**Bobs Farm Sand Mine Project (SSD 6395)  
Request for Comments and Recommended Conditions of Approval**

## Attachment A: Further information required

**Figure 7.12 - Hydrogeological Cross Section**

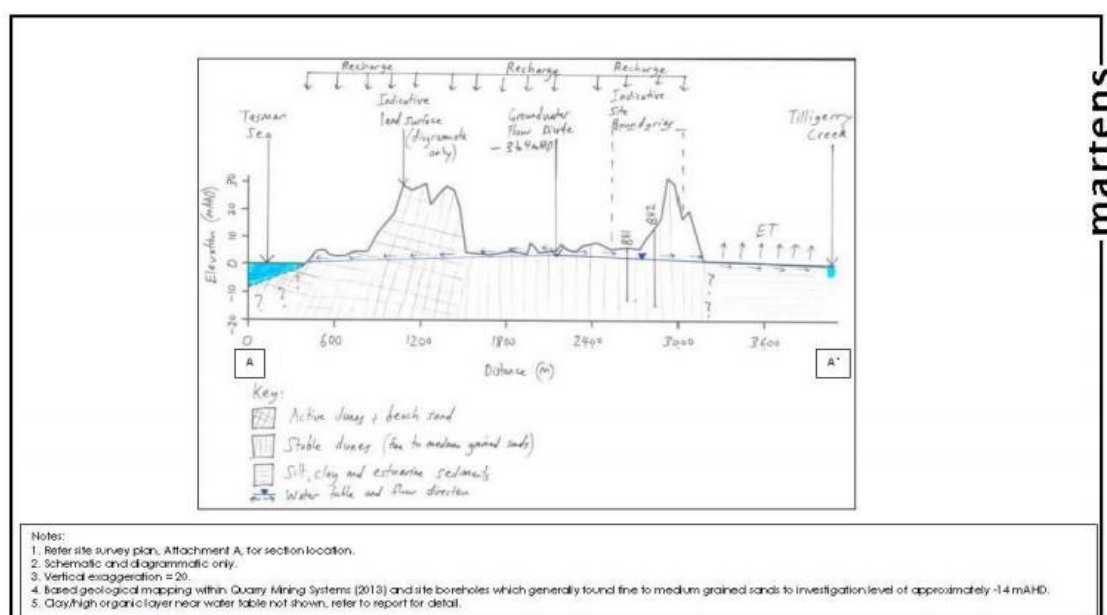
- A revised hydrogeological cross section (figure 7.12 of the EIS) to allow for easy conceptual analysis of site location. A more concise and clearer cross section would help in determining groundwater behaviour across the project site.

- Revised groundwater flow assessment. Groundwater characteristics of the project site were determined from the sampling results mentioned above. A crude schematic diagram was provided to determine the direction of flow across the site, which reveals a hydraulic gradient with groundwater flows to the north of the proposed quarry. It was determined that the hydraulic gradient, using the standing water levels from all five on-site monitoring bores, was in fact westerly to south westerly (see above below). Further groundwater sampling events and updates from the on-site loggers would be beneficial in determining the groundwater characteristics of the project site.
